Title:: Tool and Notation for Capturing and Communicating Enterprise and Technology Structures, Processes, Strategies, and Concepts

Application Number: 10/602,566

- Response to response claim 19 rejection on Pages 2-3 of the Office Action:

remarks figure 1: from Nochur

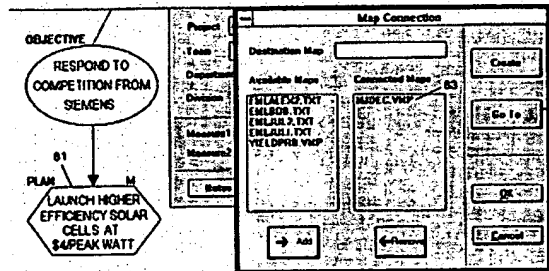
- b. Most modeling tools have objects or entities with attributes as does Nochur. Nochur uses traditional flowcharting symbols for the entity and pop-ups for the attributes. Nochur doesn't claim or have any invention in this area. My invention is in the way the information is presented. The difference in presentation is clear in remarks Figures 1&2 below. My claims 1 and 20 attempt to describe the uniqueness.

- h. Nochur pop-ups cannot contain graphics as required by my claim 20. Notice the picture of the pilot in remarks figure 2.
- i. Nochur shapes are not **predefined** with **predefined meanings** as required by my claim 1.

- j. Nochur either does not have either **predefined icons** or **predefined adornments**. In Michelle's arguments, she uses the same icon to for both. Nochur might have one (debatable) but it surely doesn't have two or more. Notice the clock and the pilot icon in remarks figure 2. Also, Michelle mistakenly considers a letter M adornment as an icon. One is text and the other is a graphic.
